**PLANNING COMMISSION STAFF REPORT
ADMINISTRATIVE ITEM**

**PLNPCM2010-00823
Sugar House Apartments
Building and Site Design Review
2025 & 2033 South 1200 East
March 9, 2011**

Applicant: Gardiner Properties

PAGE TITLE
**MAIN LEVEL FLOOR PLAN
 (NORTH BLDG)**

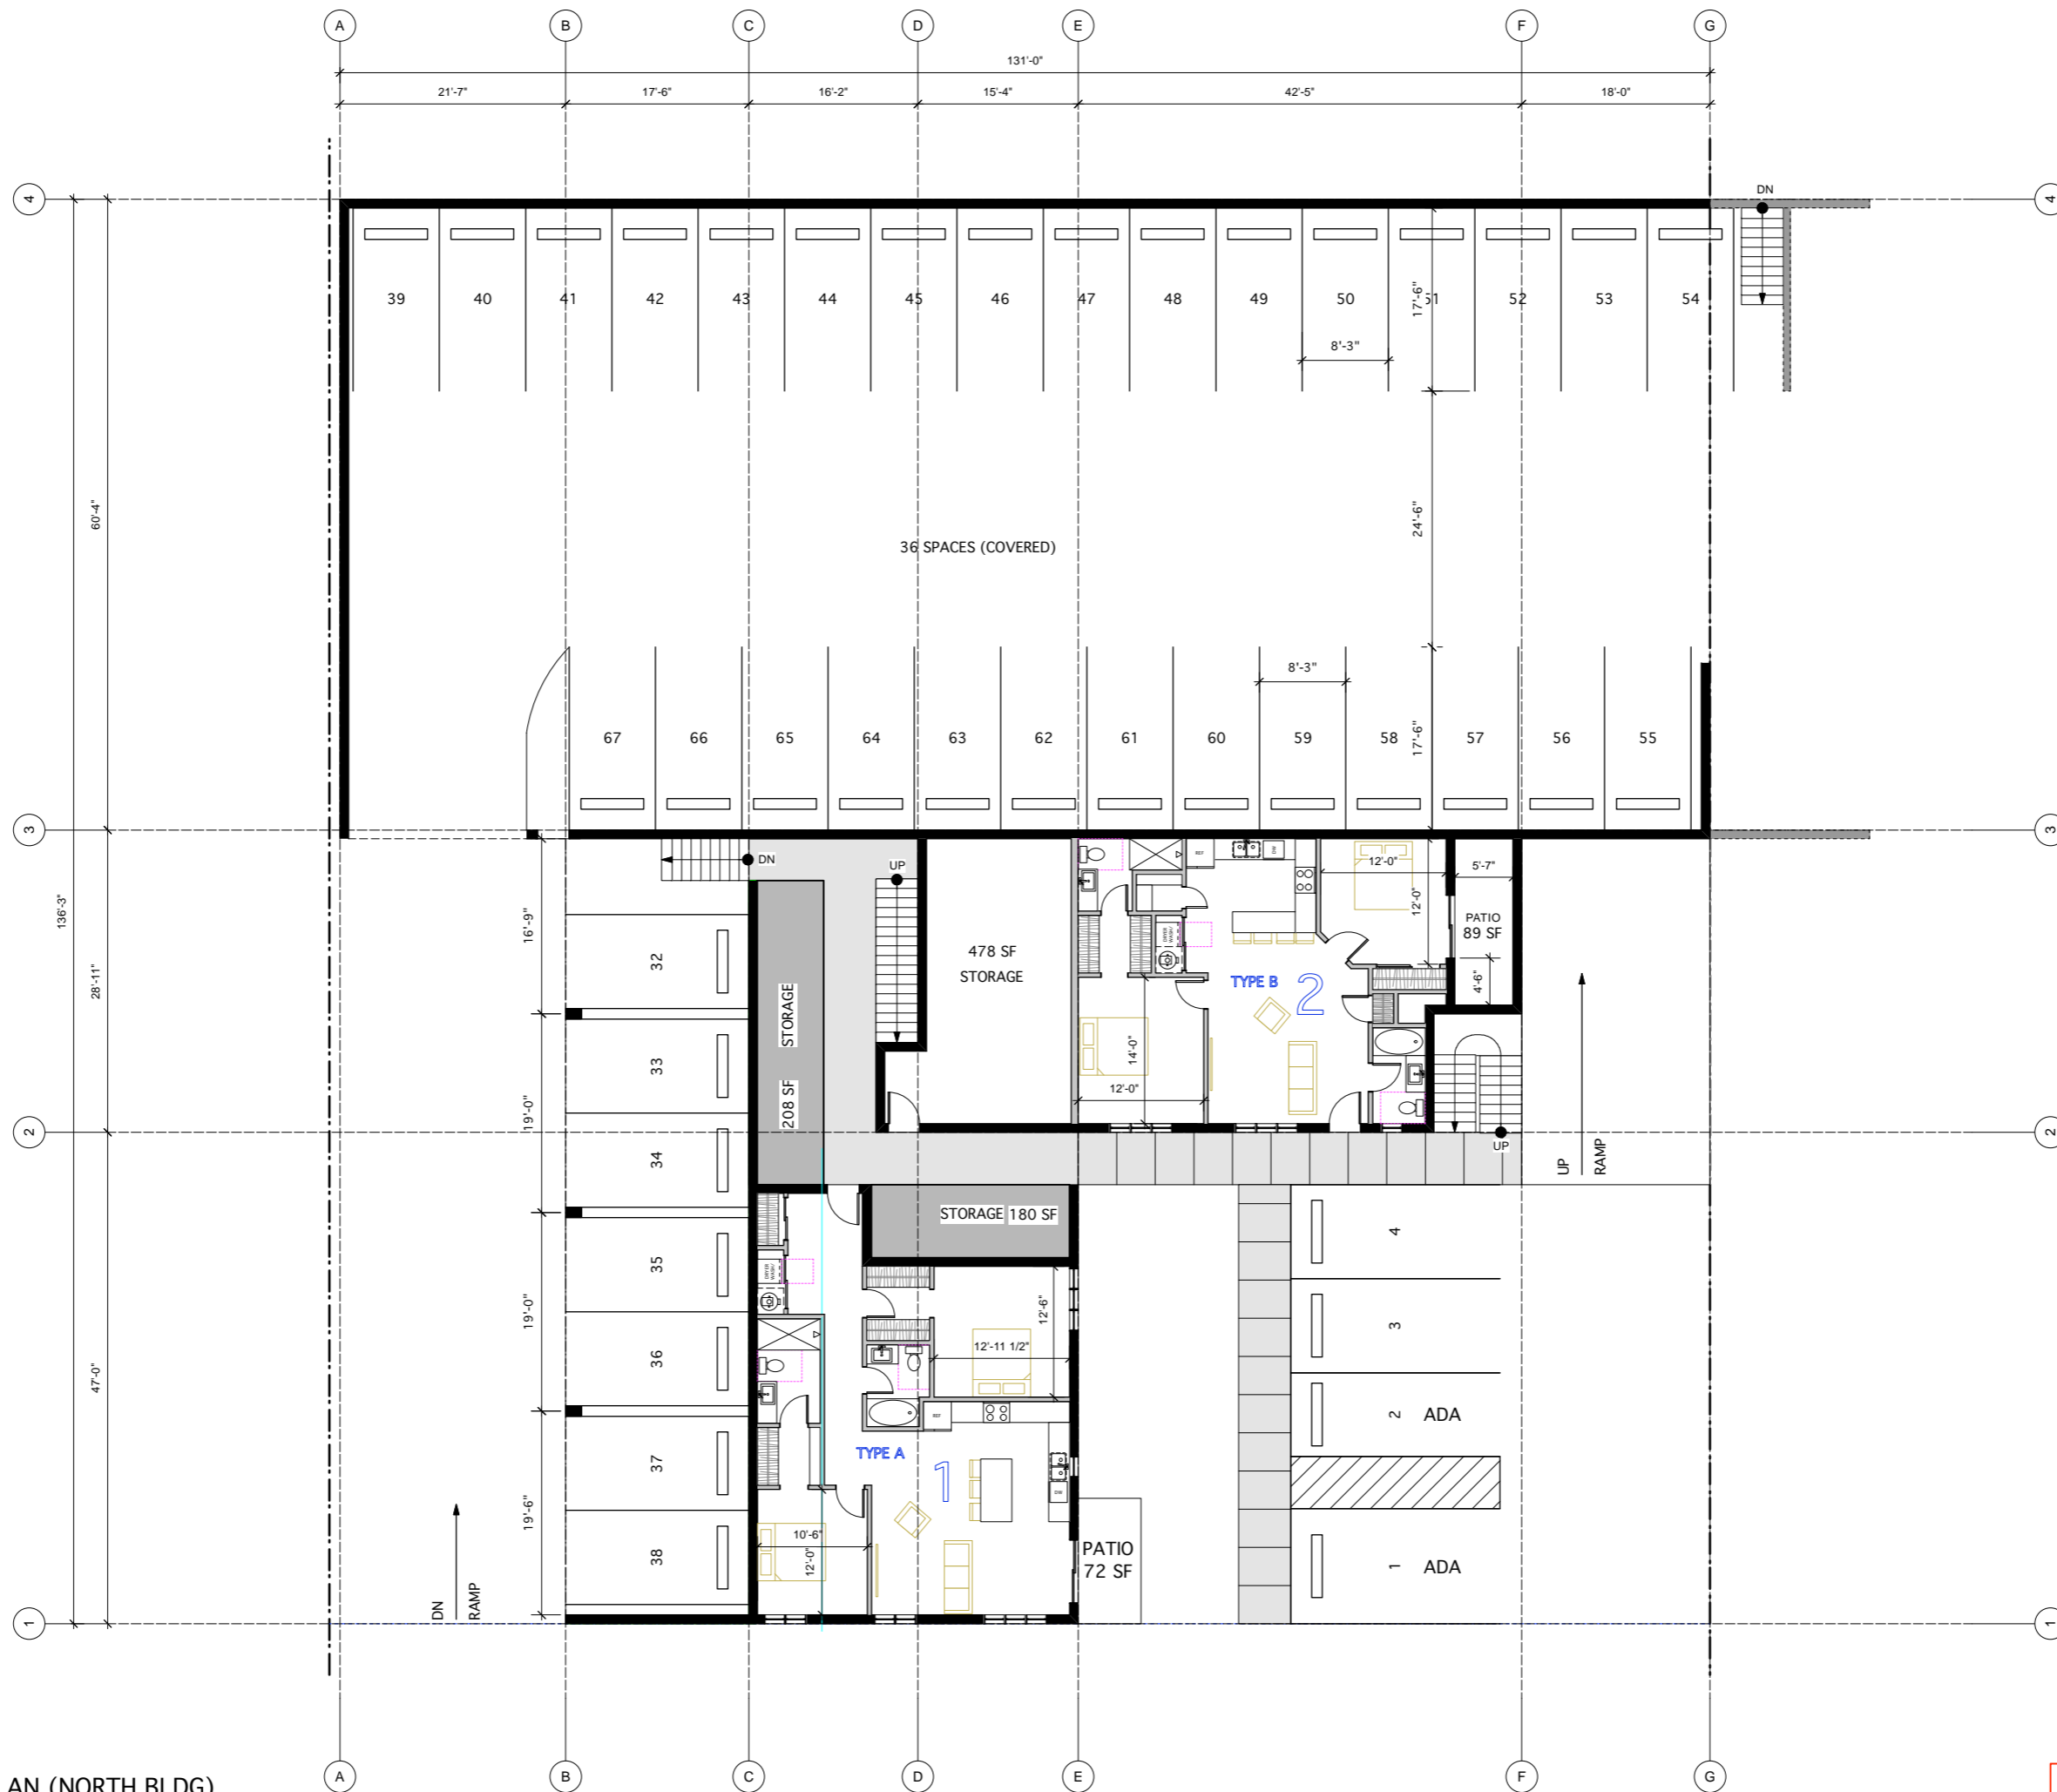
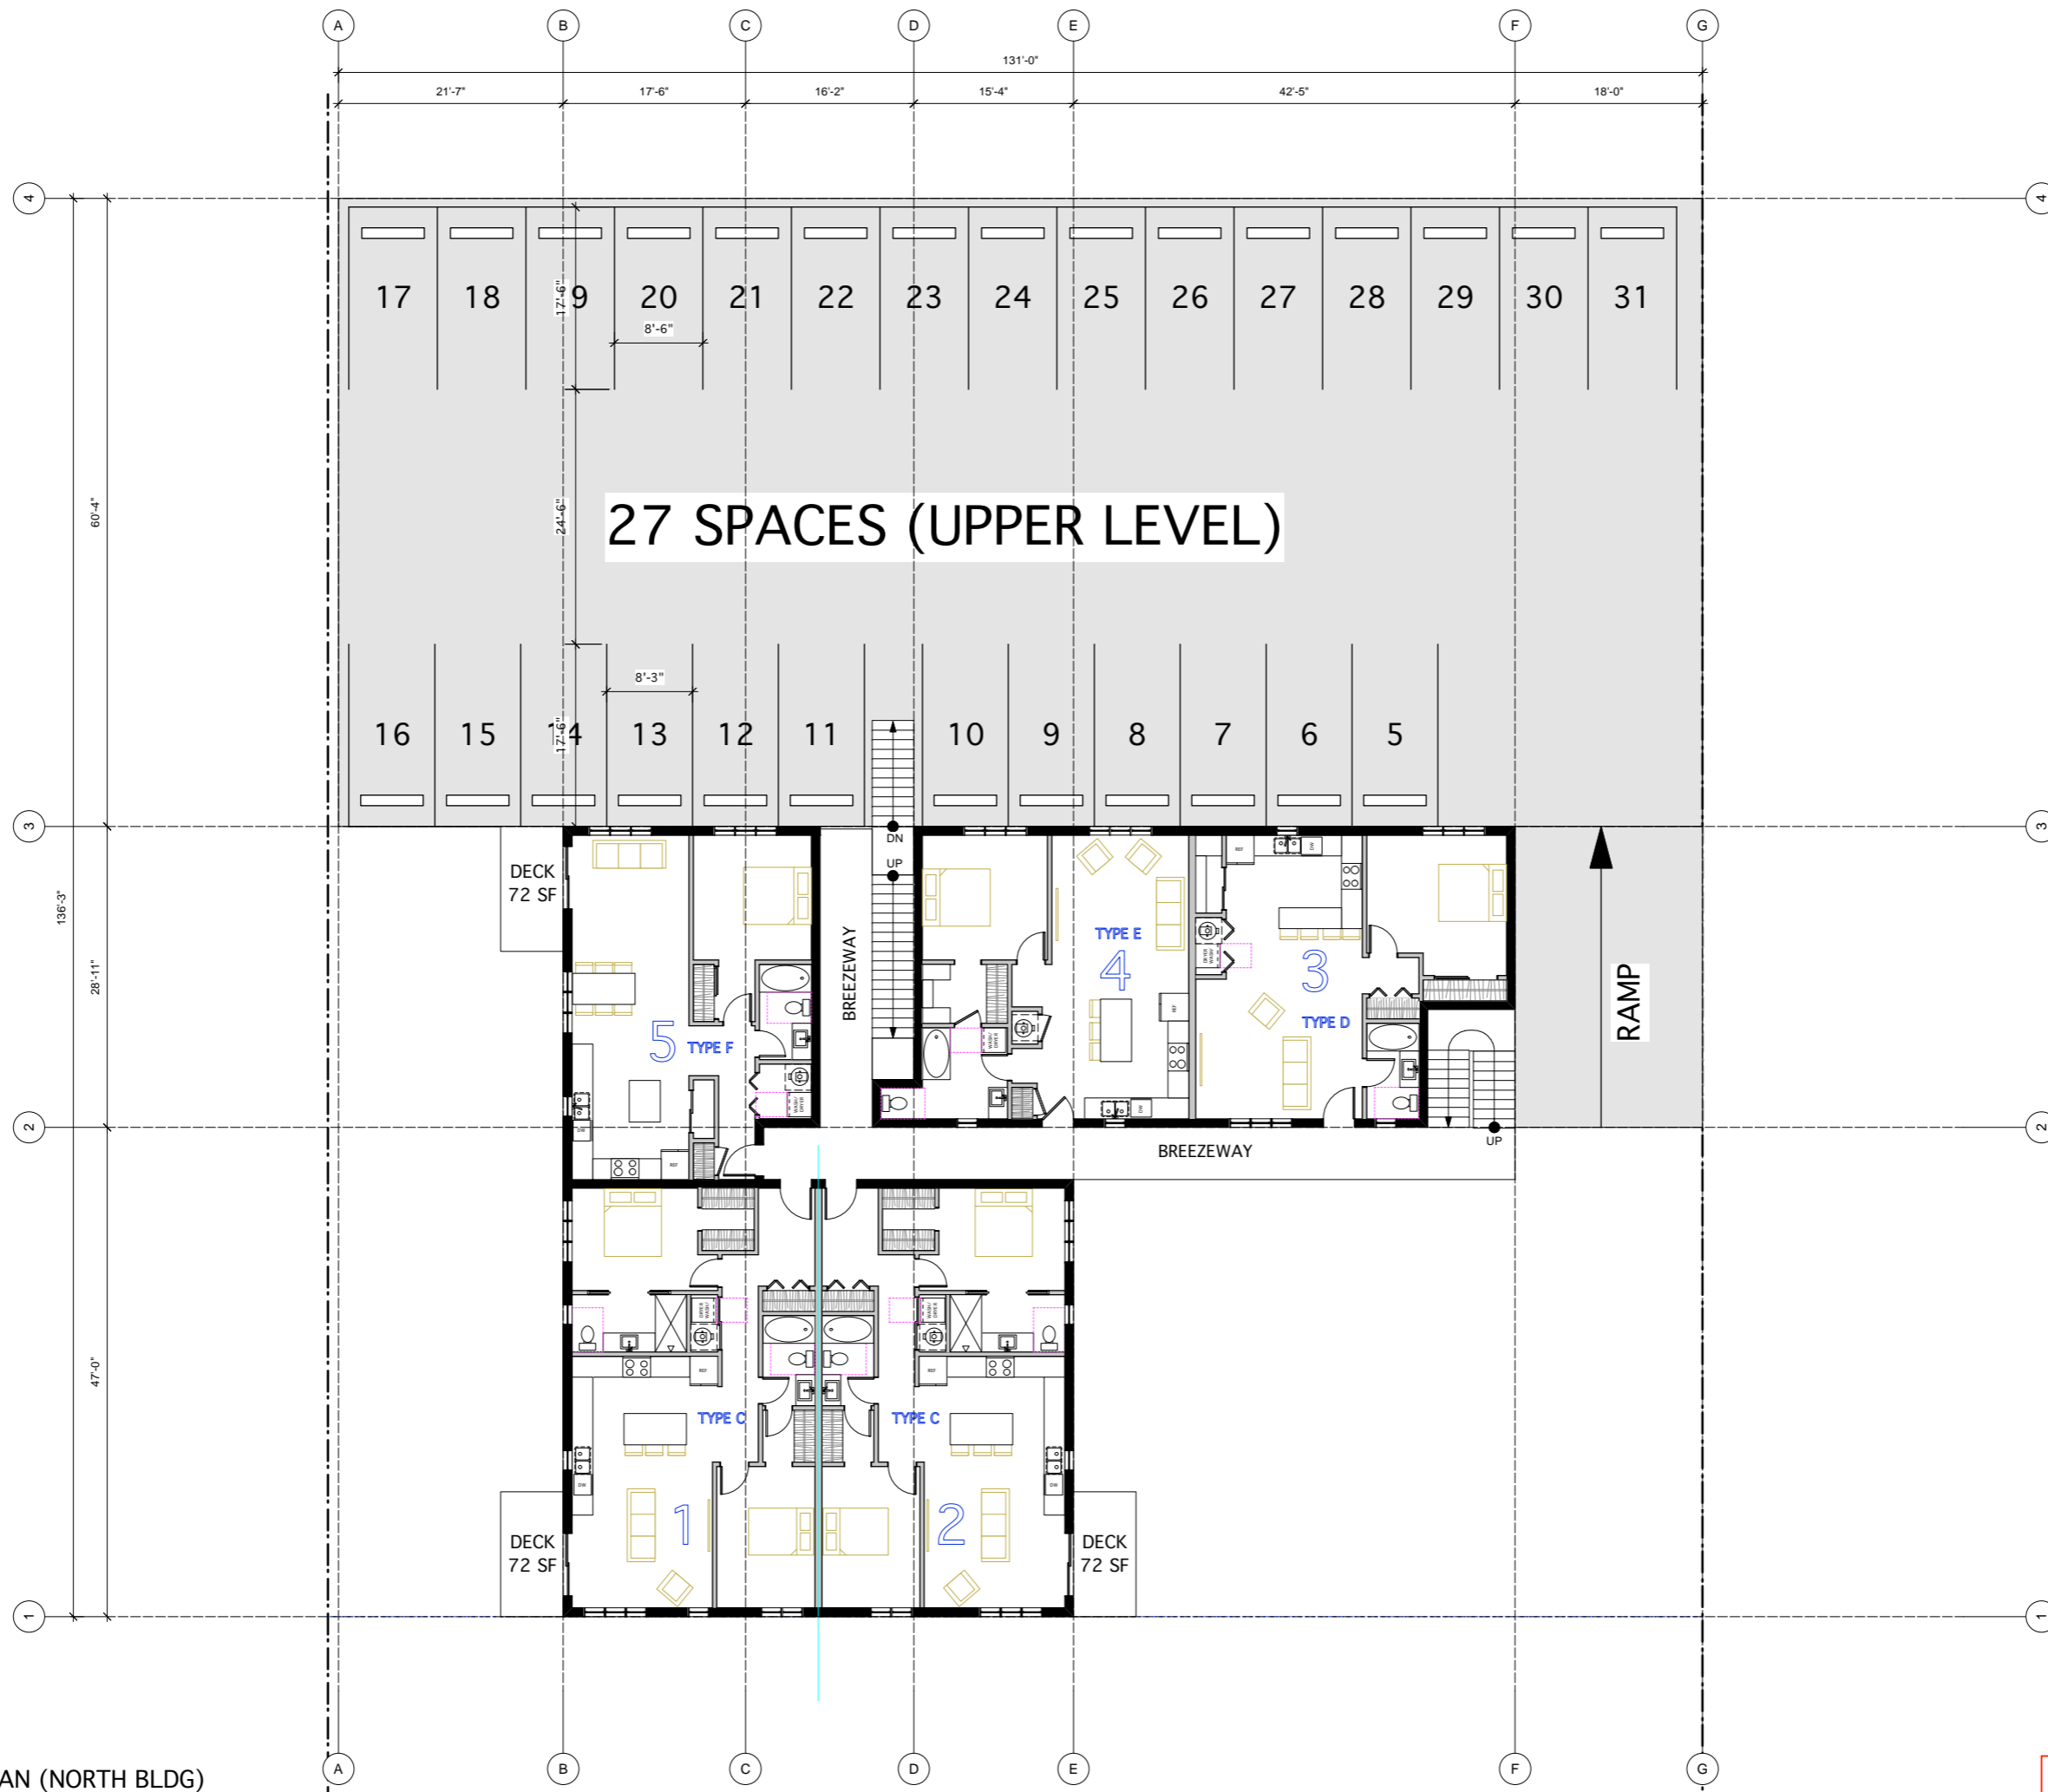
- How was the required handicap spaces calculated? (4 stalls per 0-99 are indicated on plans SLC code 21A.44.020.D)
- The building plans submitted for the north building need to be as detailed as the plans submitted for the south building. (Plans have been detailed see sheets AN1.1-1.4)
